Co3237 Poultney BF 0145(13)

ADDENDUM #1

- Invitation for Bids, and Proposal to extend Bid Opening to June 13, 2025, and update the Schedule of Items.
- Special Provision Pages 1 and 6.
- Plan sheets 3, 10, 11, 44-52, 57, 63, 65, 79-82, 93, 94, 96, and 97.
- New Impact Plans shall replace Pages 136 to 171 in the Proposal.

PROJECT NAME:	POULTNEY	PLOT DATE:	5/19/2025
PROJECT NUMBER:	BF 0145(13)	DRAWN BY:	N.A. TRUSLOW
FILE NAME:	z21j164gusset.dgn	CHECKED BY:	J.D. KEENER
PROJECT LEADER:	J.D. KEENER	SHEET	46 OF 115
DESIGNED BY:	N.A. TRUSLOW		
GUSSET PLATE DETAILS

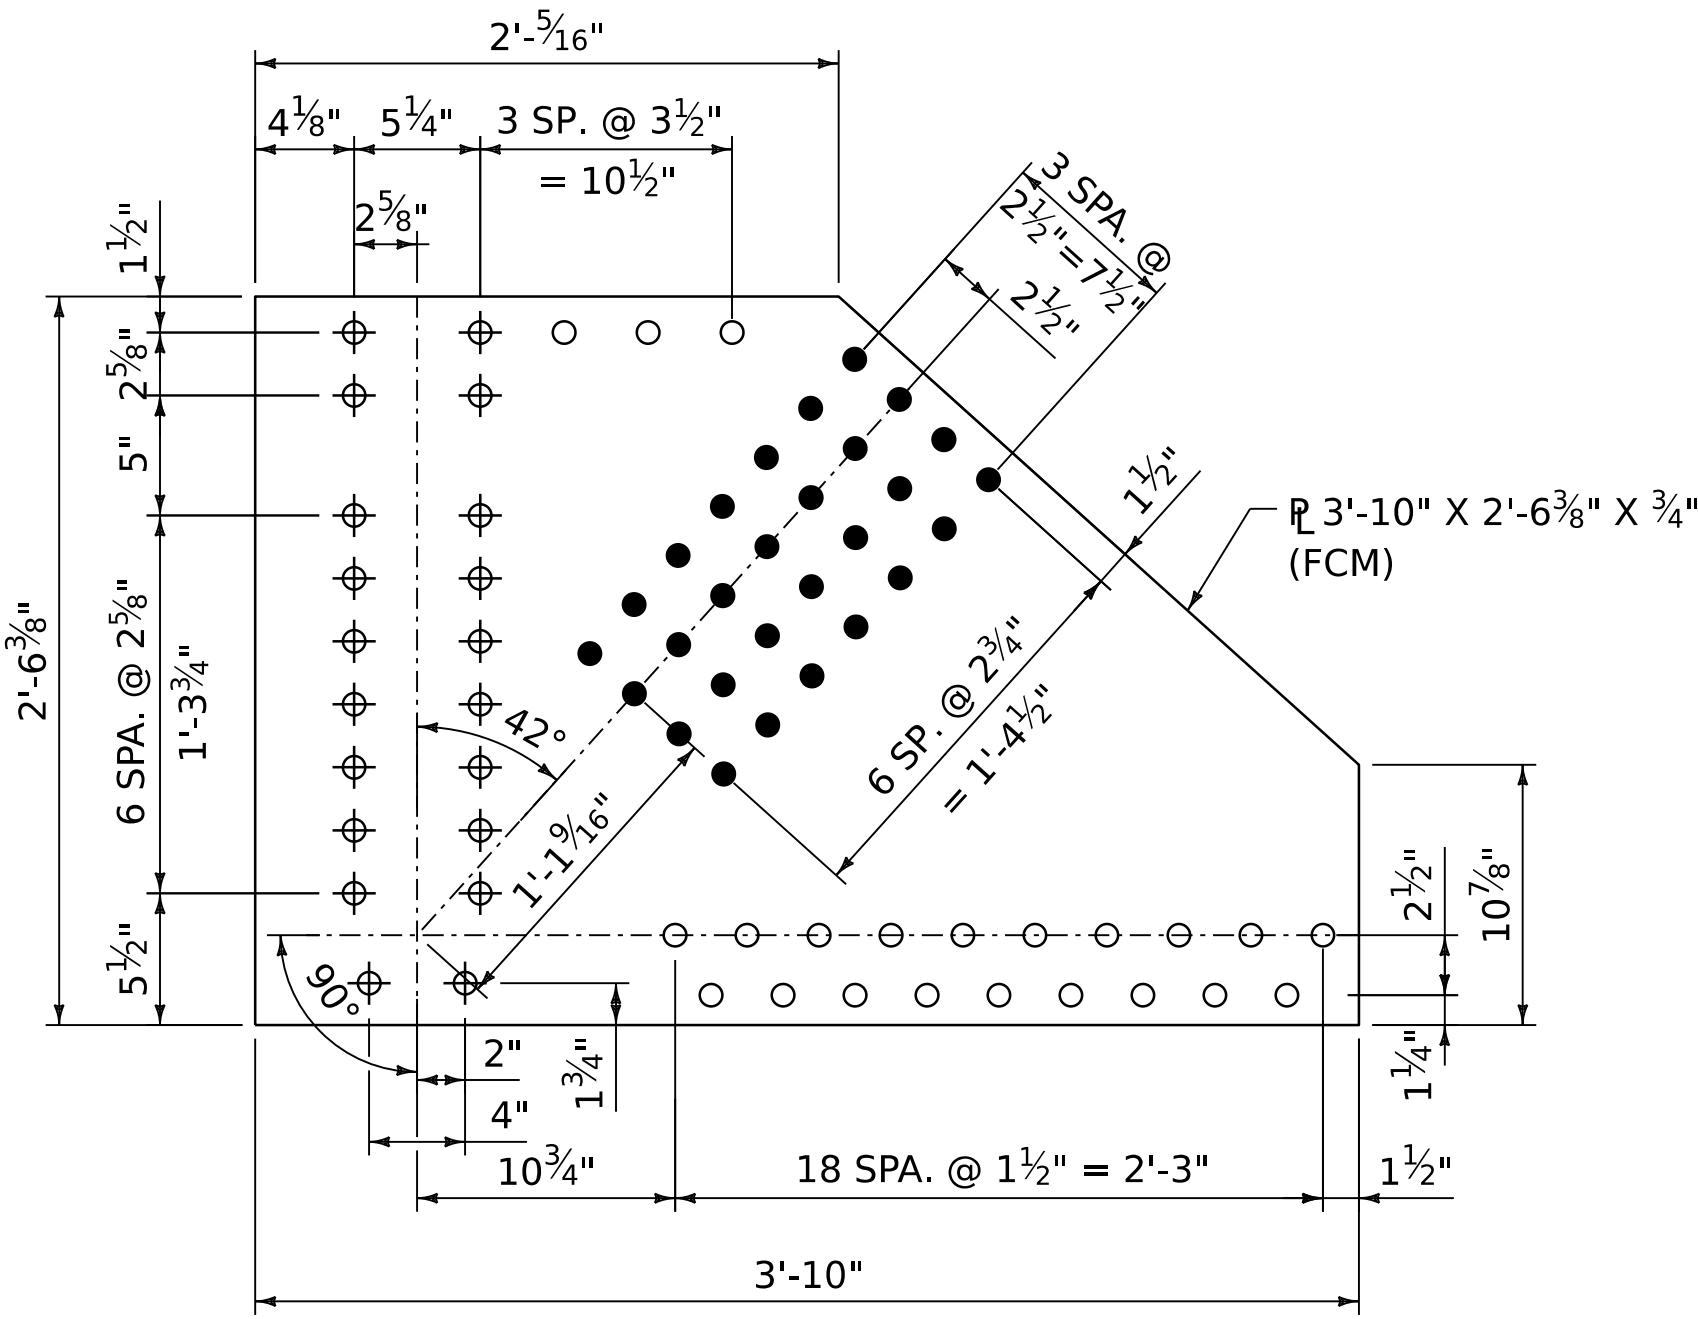
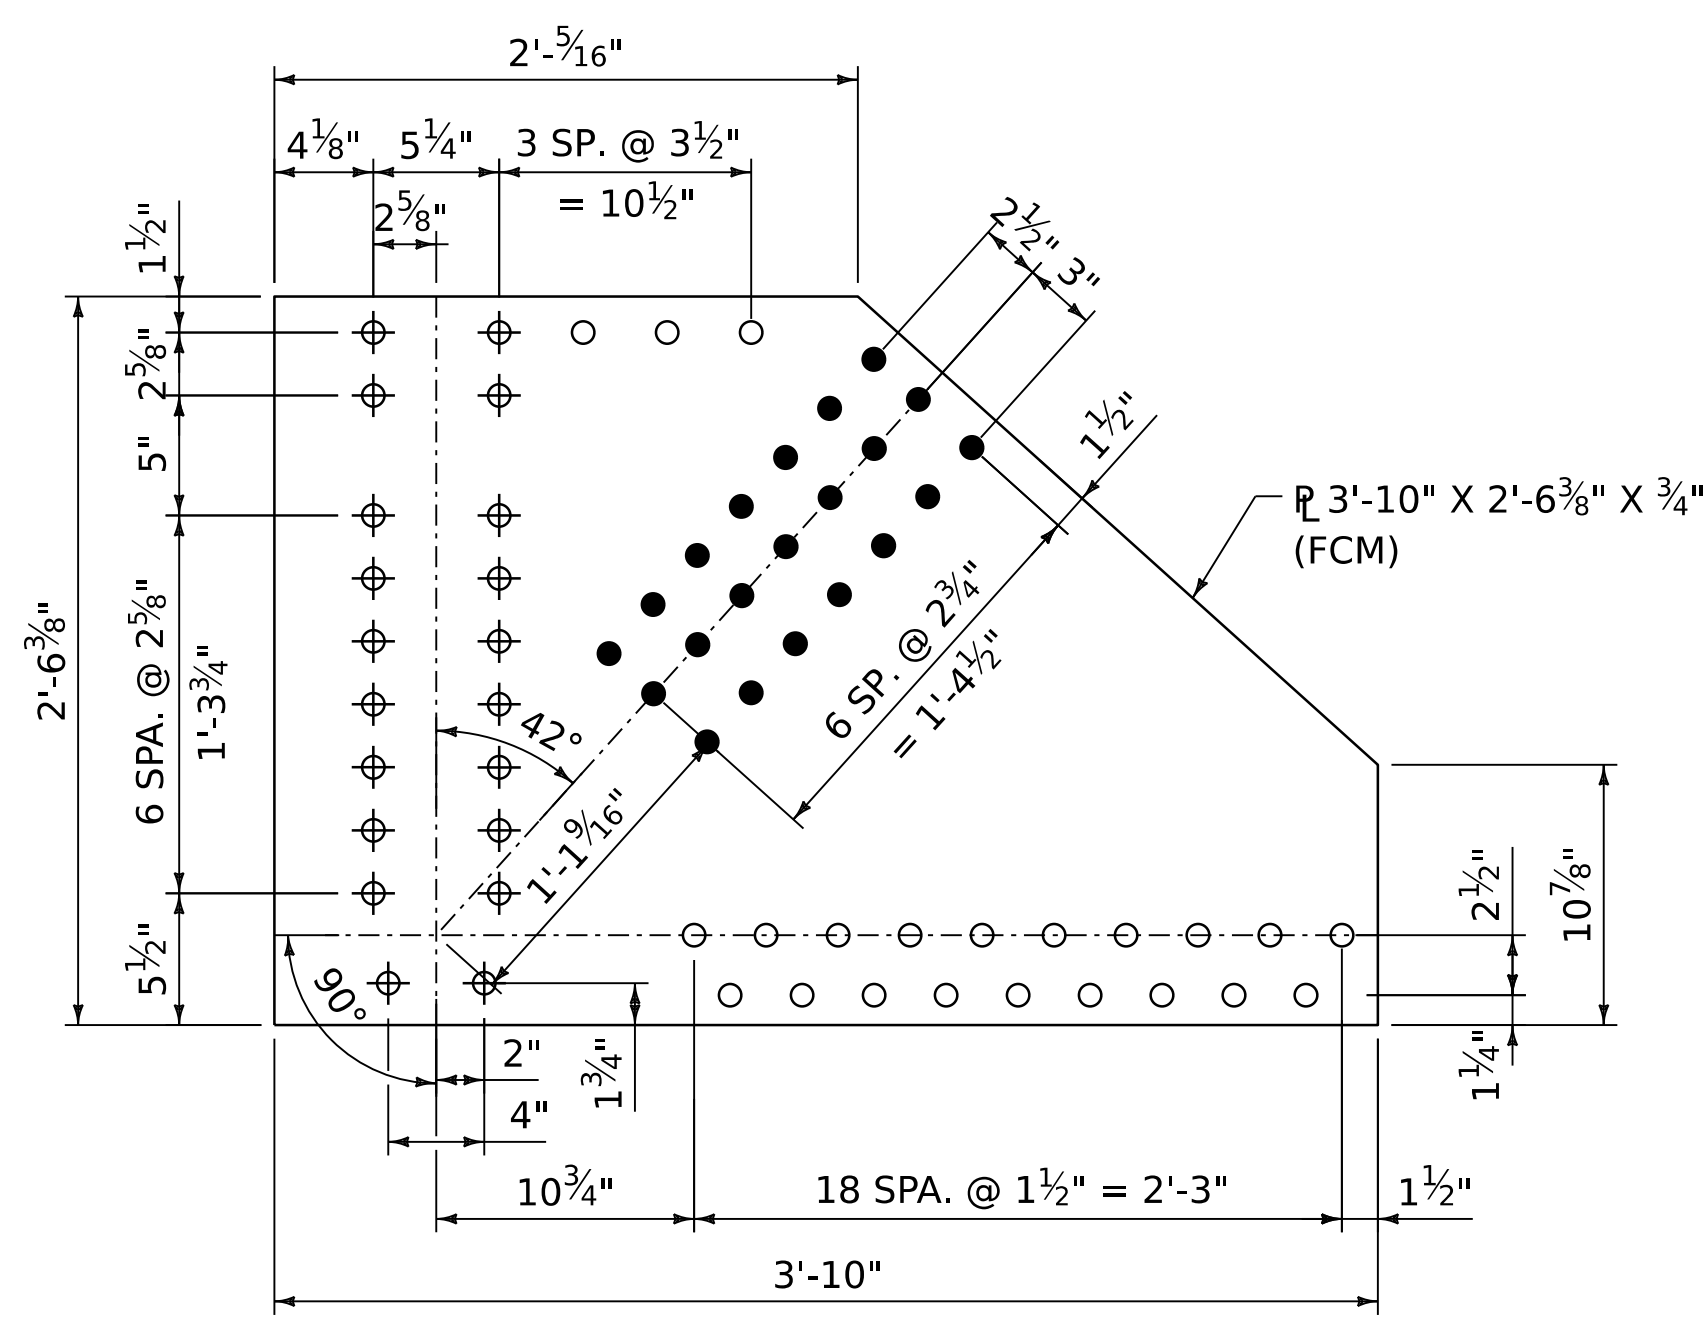
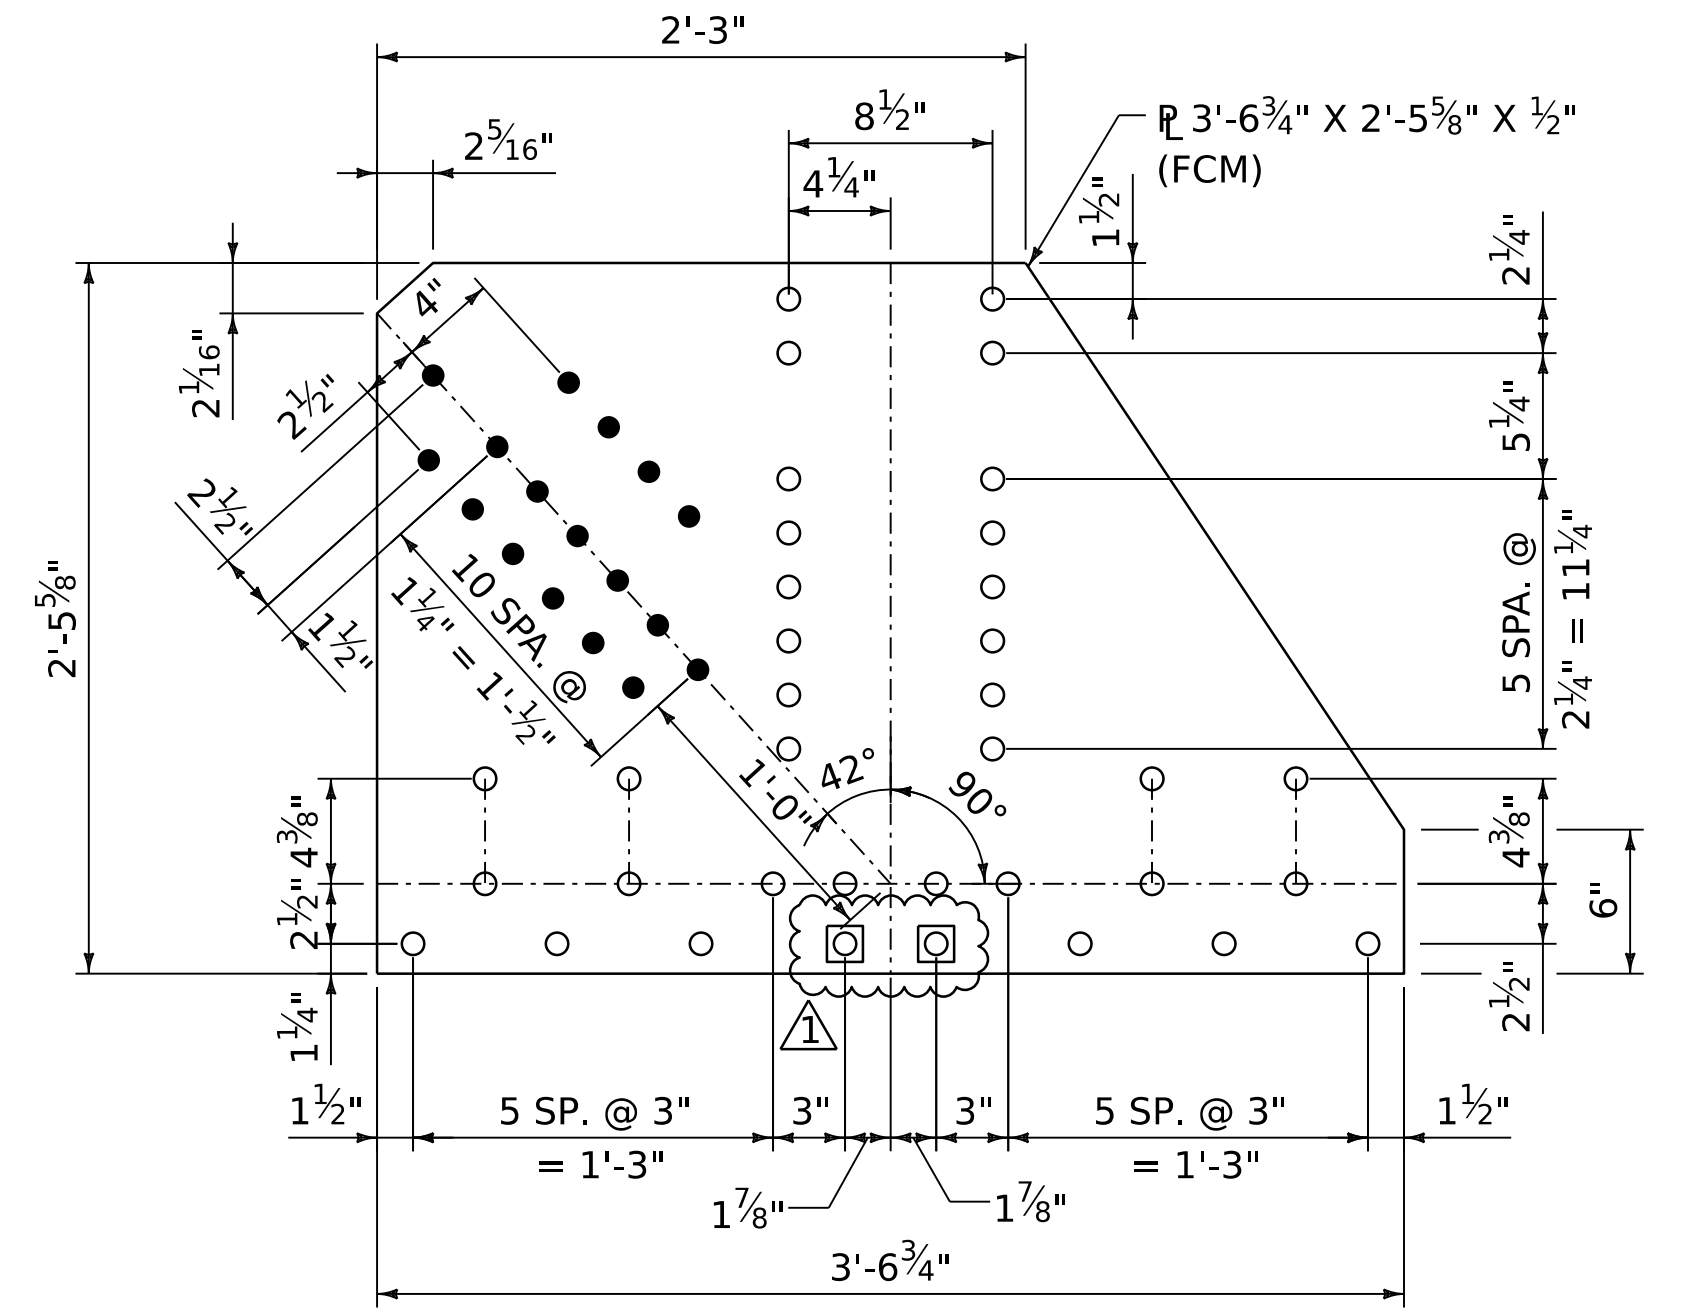
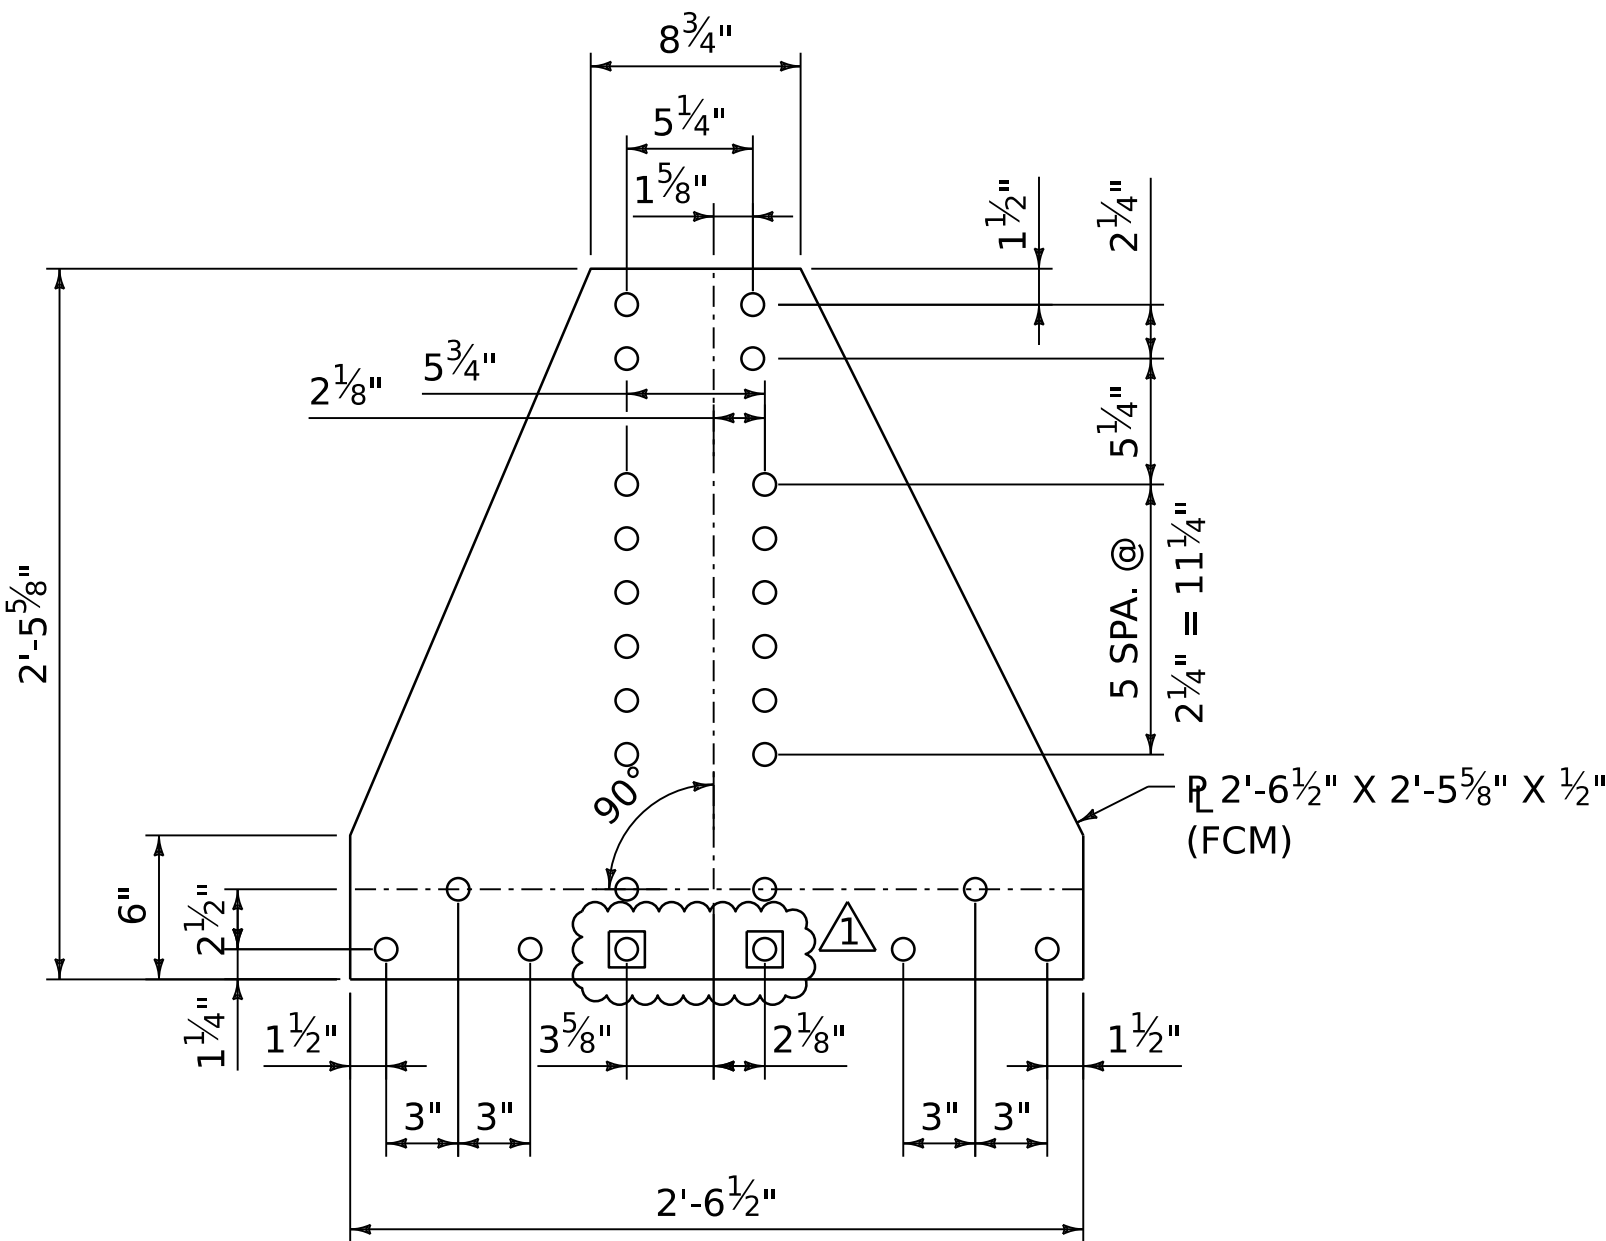
ADDENDUM	REVISION	PLOT DATE	DESCRIPTION	BY
⚠	1	5/19/2025	ADDED BOLTS TO EXTERIOR GUSSET PLATES	RHB
